# Access Compliance Report

## Public Rights-of-Way

### (Curb Ramps)

Intersection ID: 3992	Main Street: BENTHAVEN_LN	Cross Street: BROWNE'S_FERRY_RD	Location: SW
ADA ID: E60C8EC4BB77	Ramp Type: Perp	Initial Pass/Fail: Pass	Overall Compliance: No
Severity Score: 10.25			
Codes/Mitigation Info/Possible Solution		Field Measurements/Component Compliance

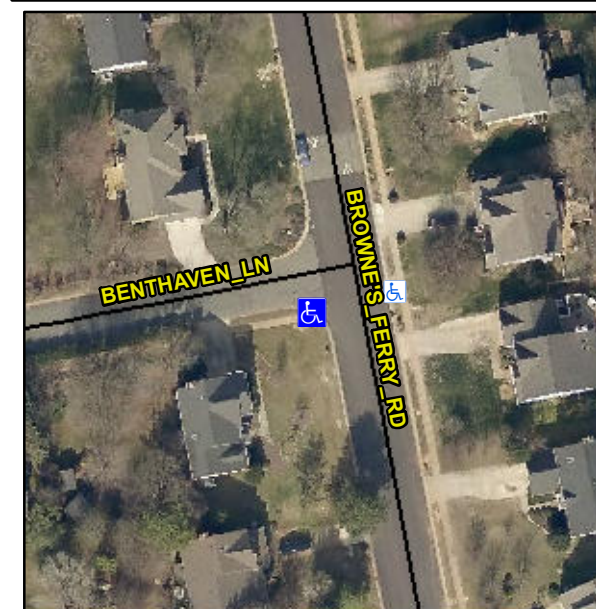
**Remove & Replace Entire Ramp.  
Remove & Replace Gutter.**

**Not Found, R304.5.3, R305**
